| Project:  | 76 Priory Road, NW6 3NT<br>Mr. & Mrs. W. Grigull | 76PR   |
| Proposed: | Site Plan                                        | P001   |
| Status:   | Planning                                         |        |
| Date:     | January 2008                                     | Rev: A |

| Proposed: | Upper Ground floor plan                          | P003             |

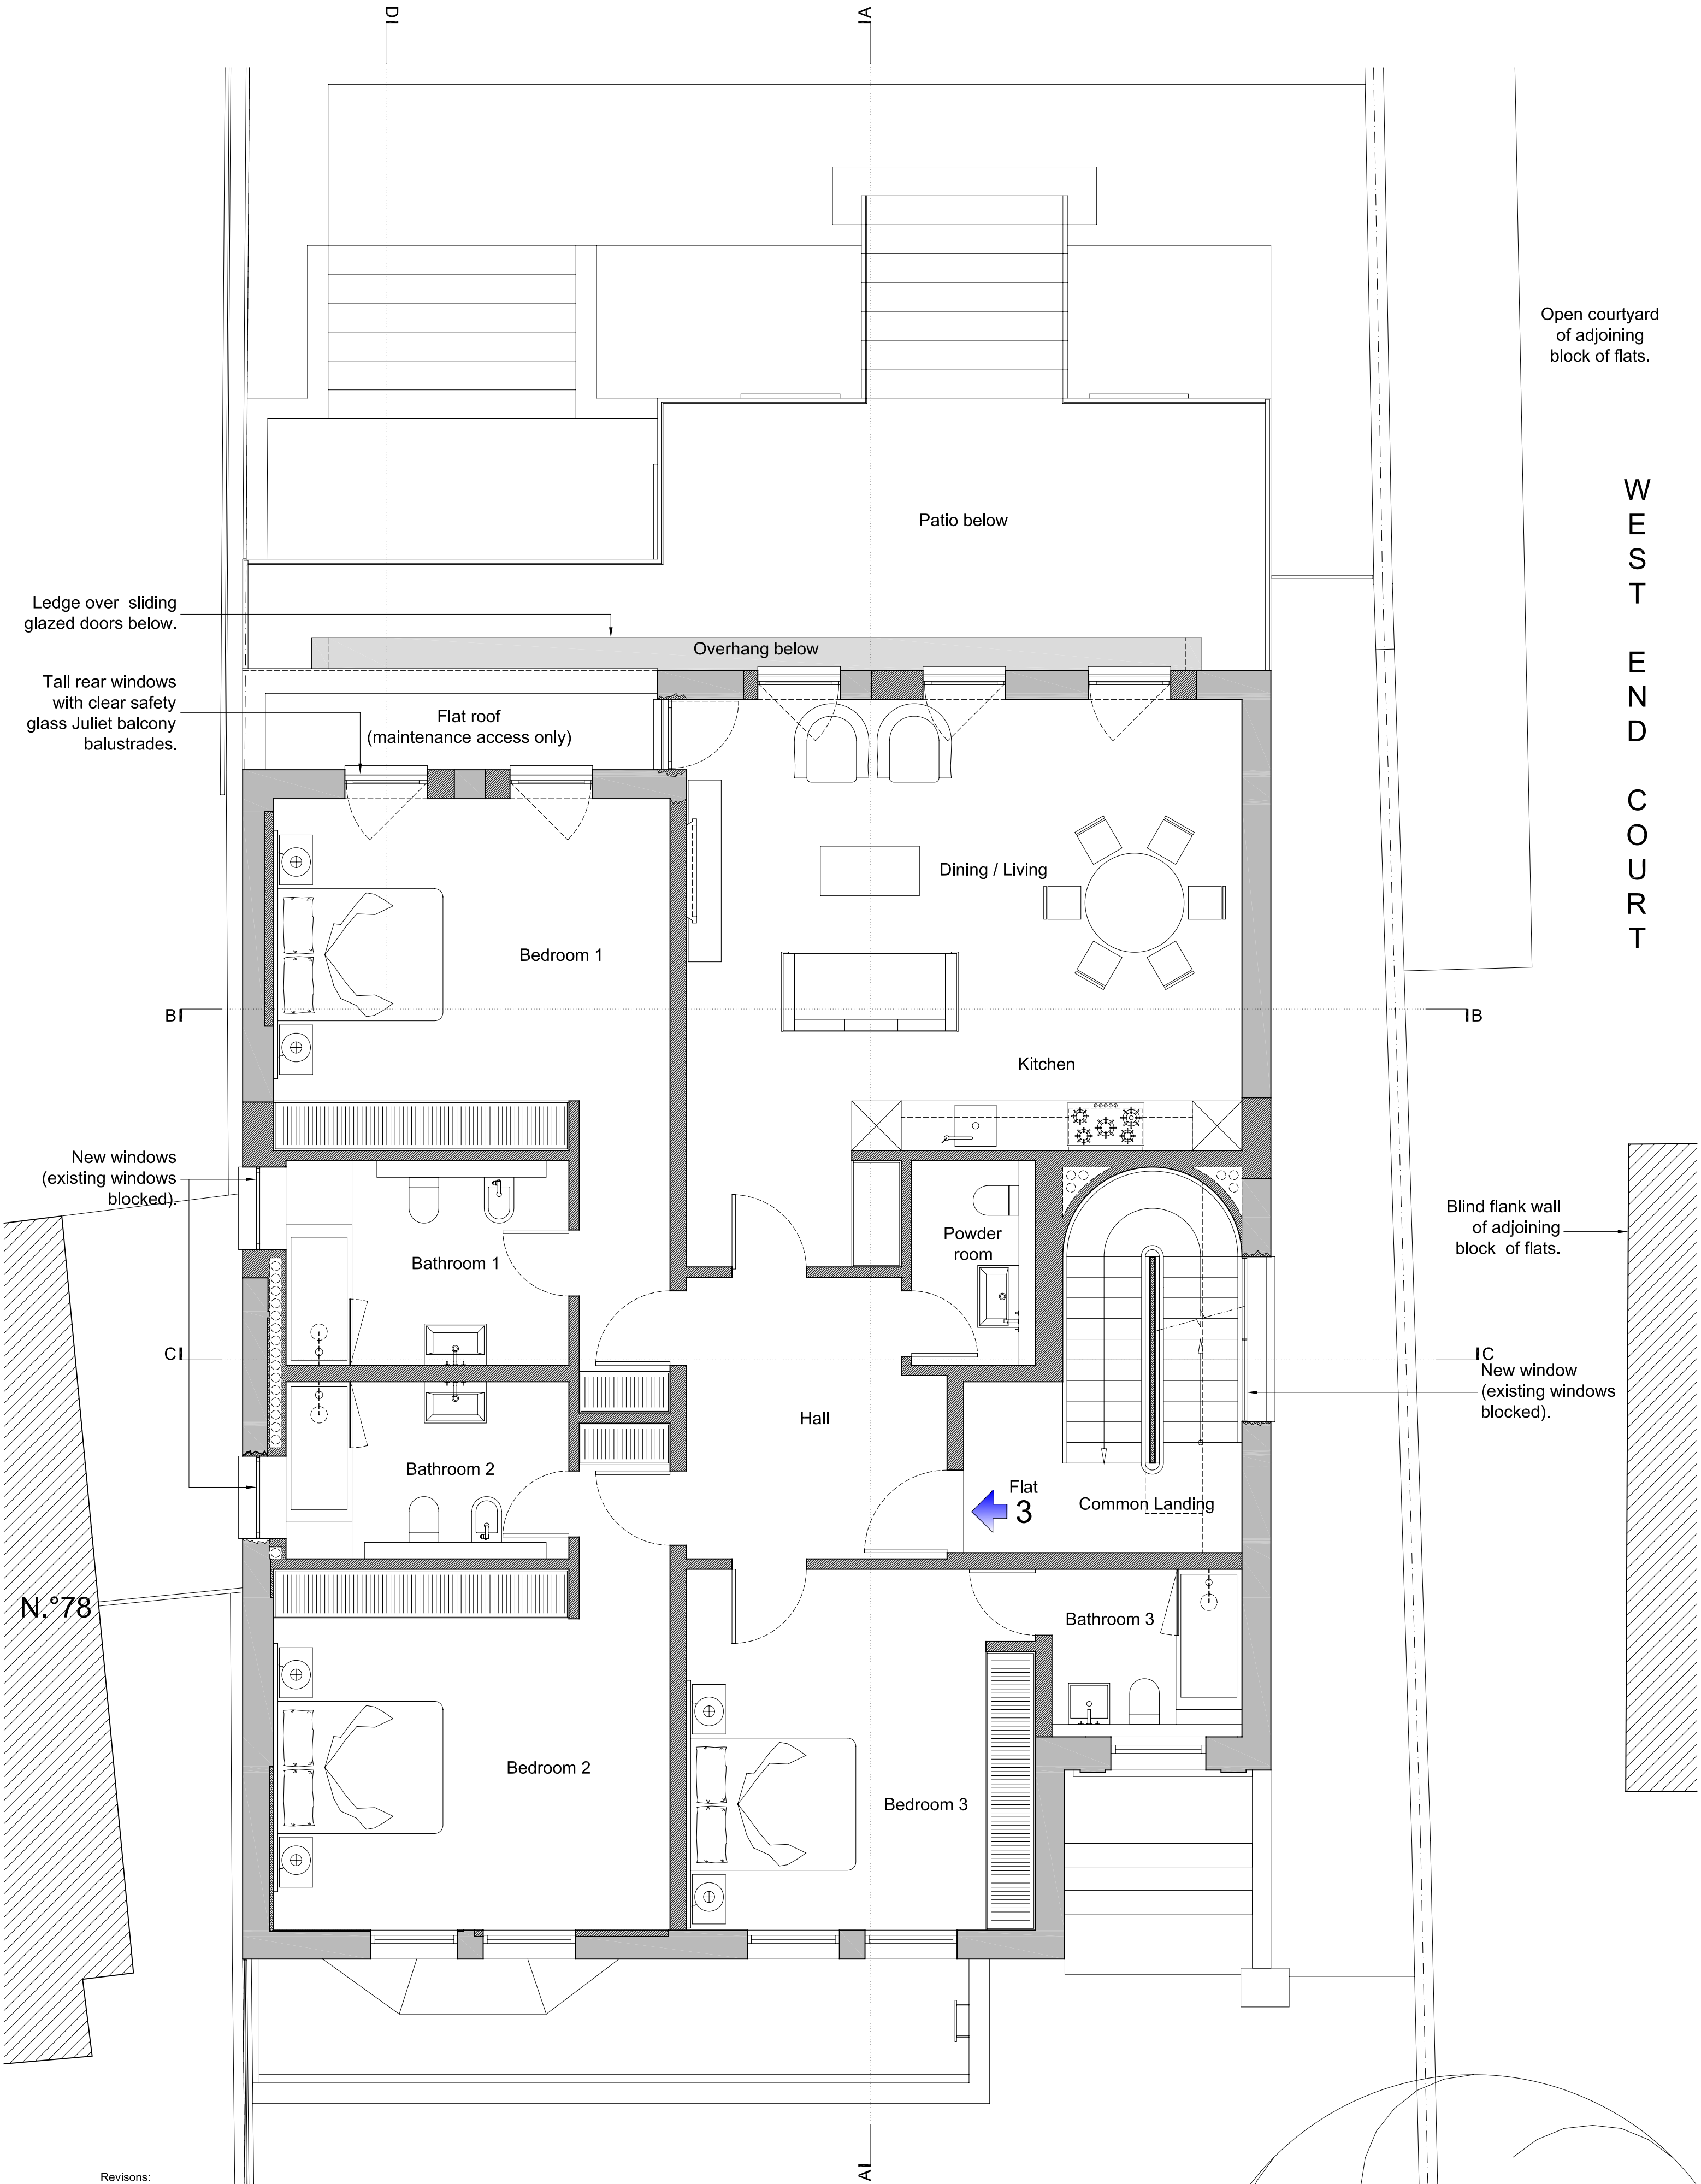
Revisions:  
Rev A: 05-03-2008  
\*Mansard roof on side entry annex revised to Hip roof form.  
\*Chimney note added.  
\*Railings to front light well removed & horizontal grill added.  
\*Roof lights to sit flush with roof profile.  
\*Rear dormer windows revised to sit within existing position.

| Proposed: | First floor plan                                 | P004             |

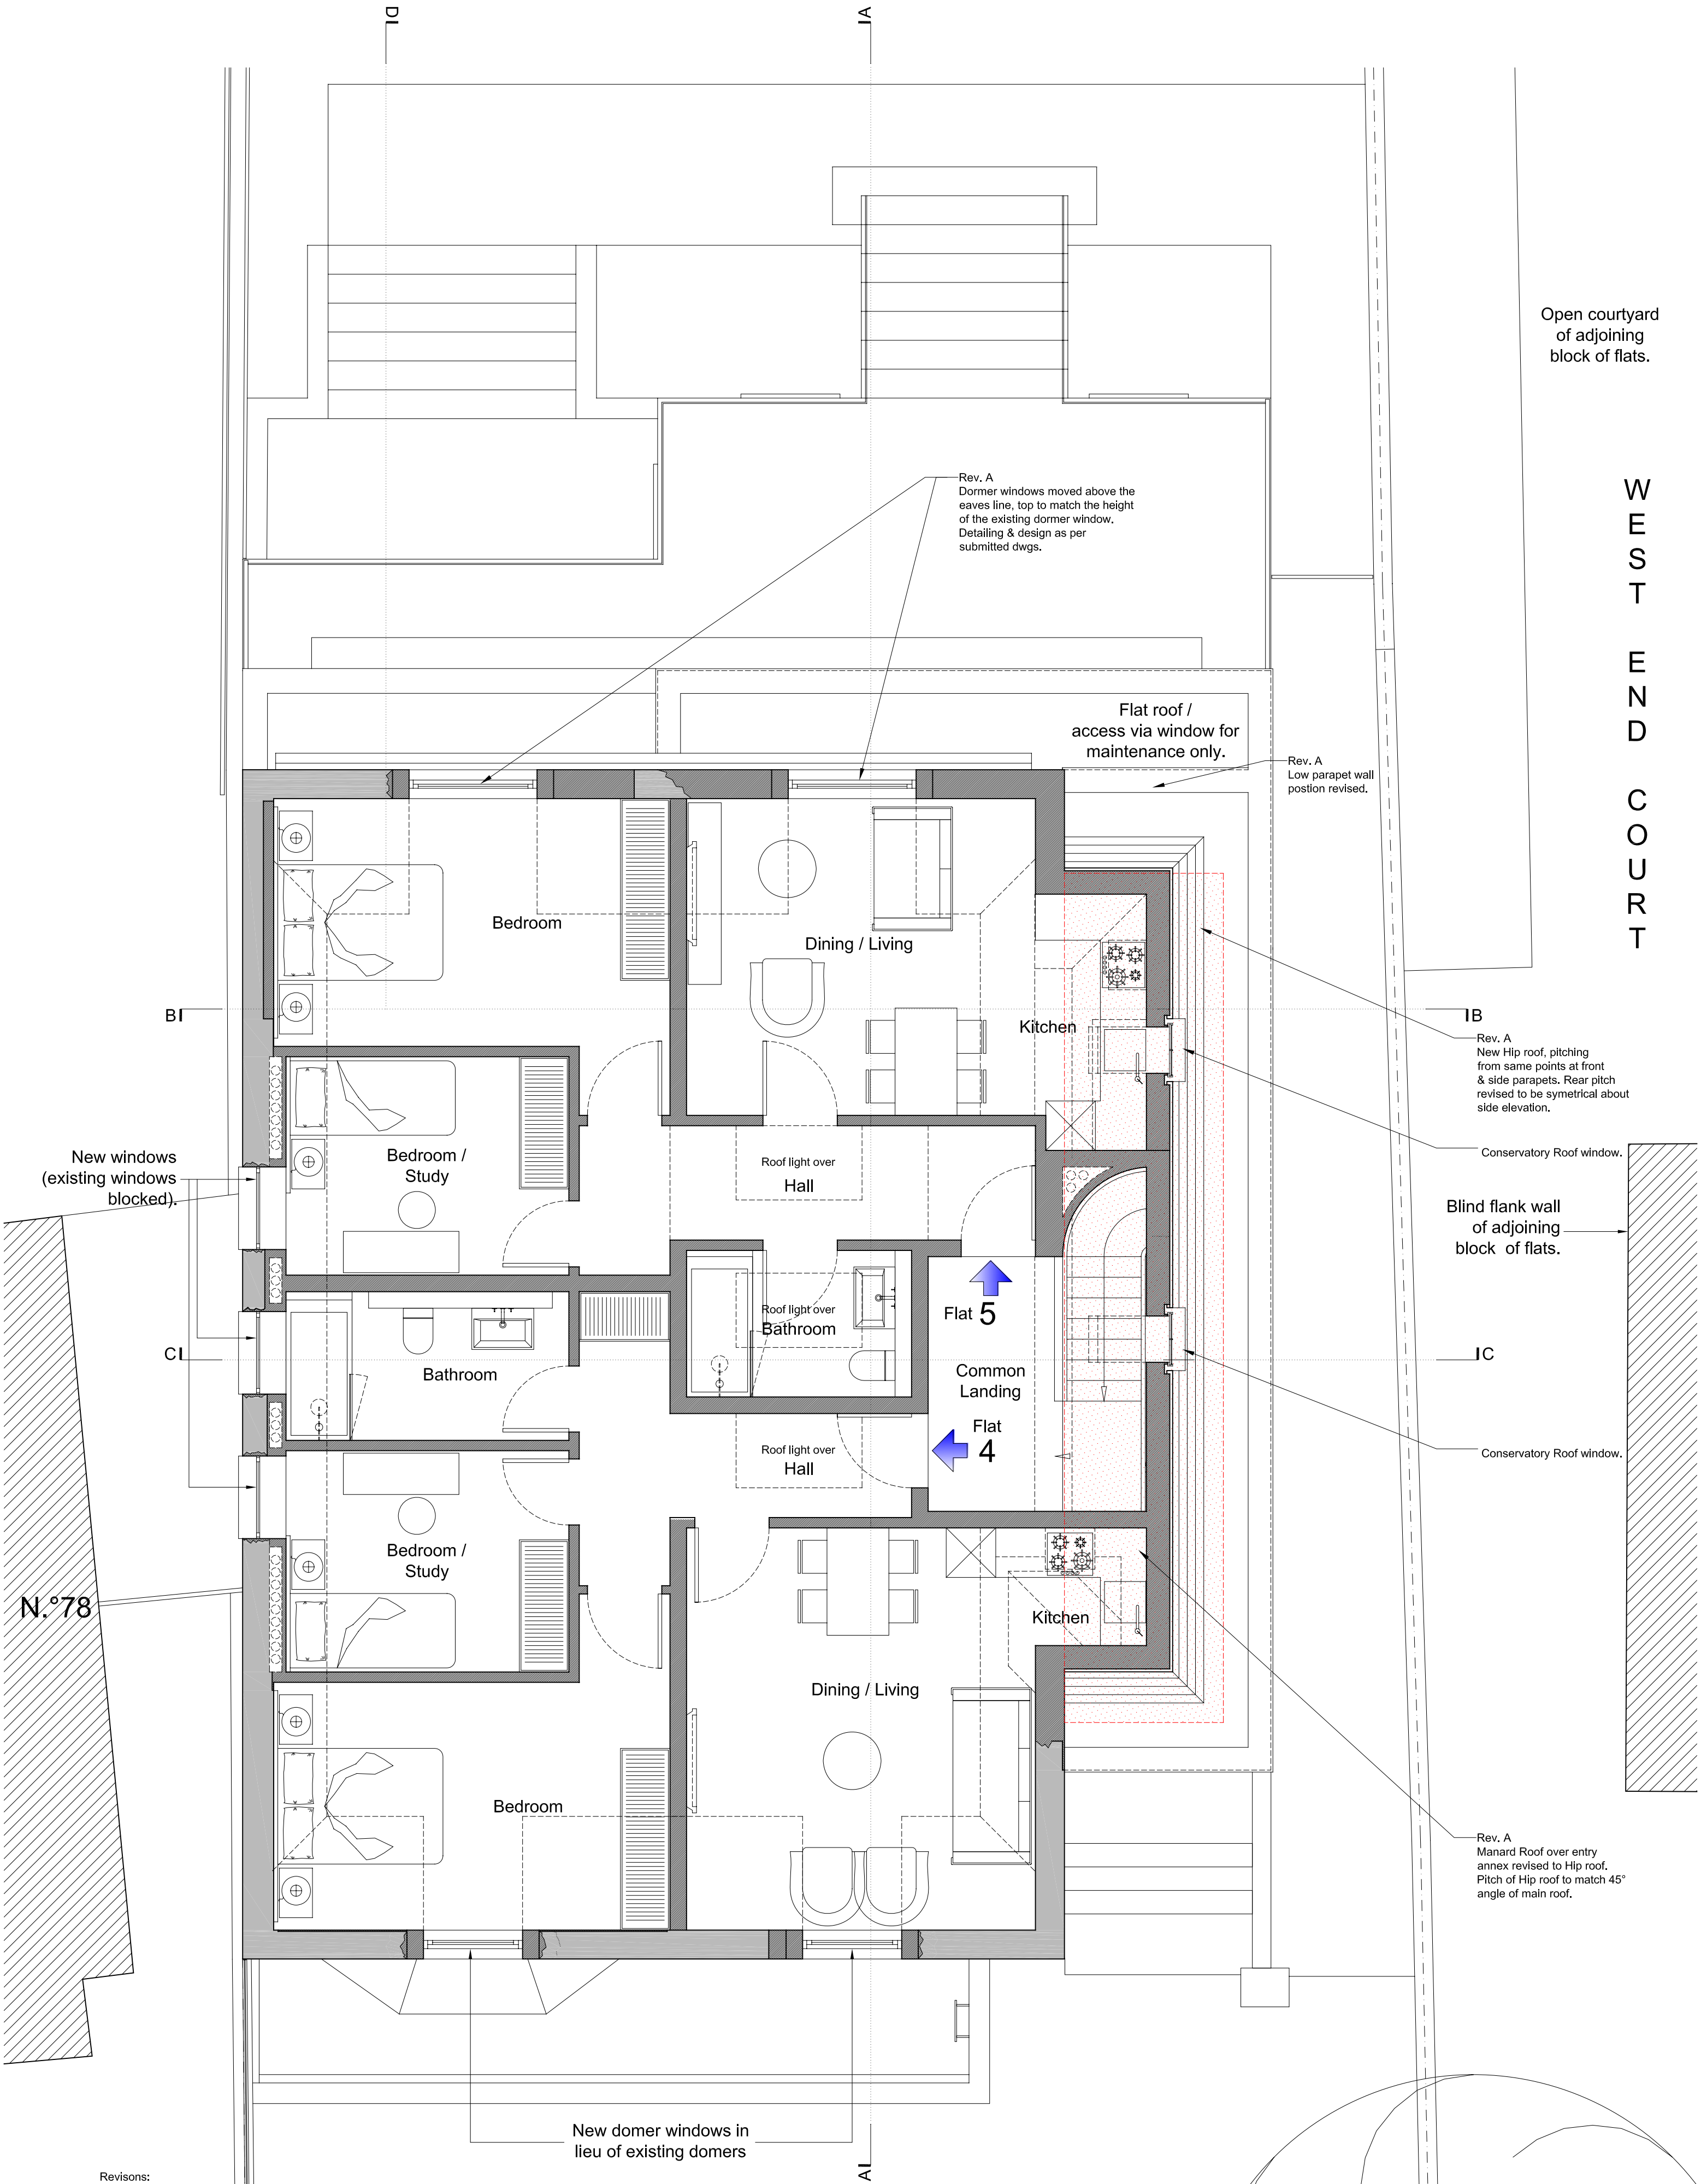
Revisions:  
Rev A: 05-03-2008  
\*Mansard roof on side entry annex revised to Hip roof form.  
\*Chimney note added.  
\*Railings to front light well removed & horizontal grill added.  
\*Roof lights to sit flush with roof profile.  
\*Rear dormer windows revised to sit within existing position.

| Proposed: | Second floor plan                                | P005             |

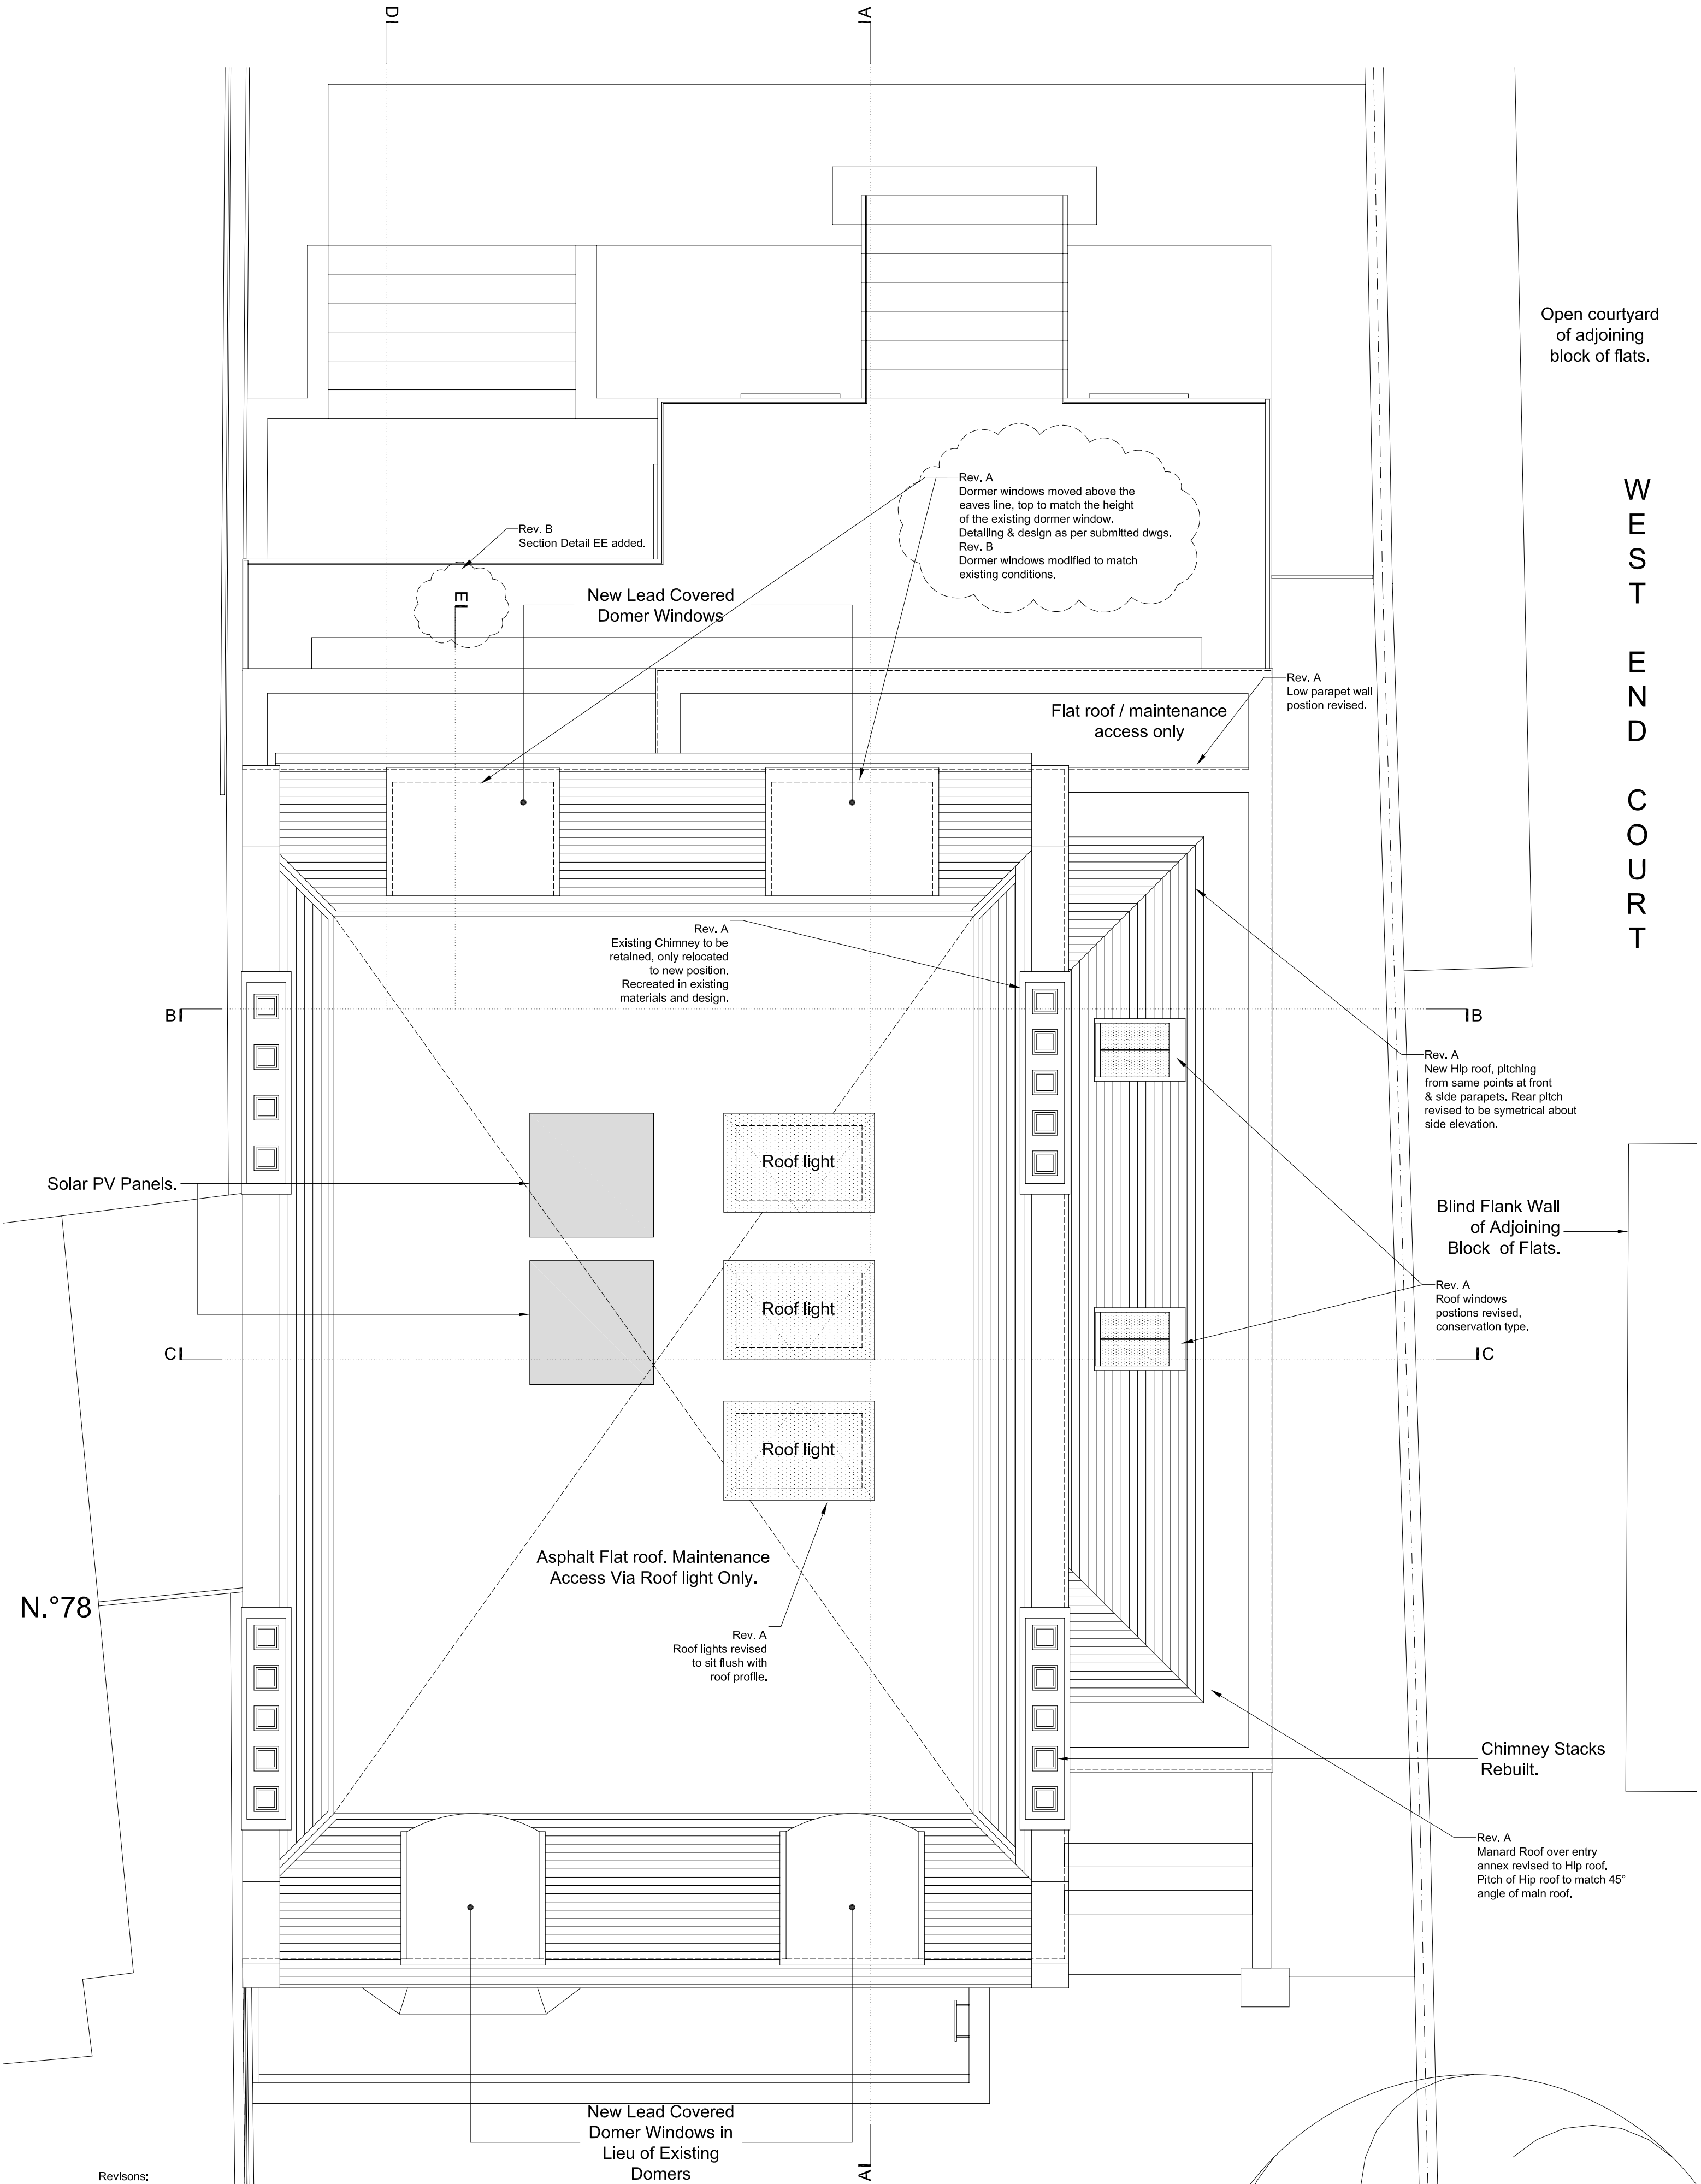
Revisions:  
Rev A: 05-03-2008  
^Mansard roof on side entry annex revised to Hip roof form.  
^Chimney note added.  
^Railings to front light well removed & horizontal grill added.  
^Roof lights to sit flush with roof profile.  
^Rear dormer windows revised to sit within existing position.
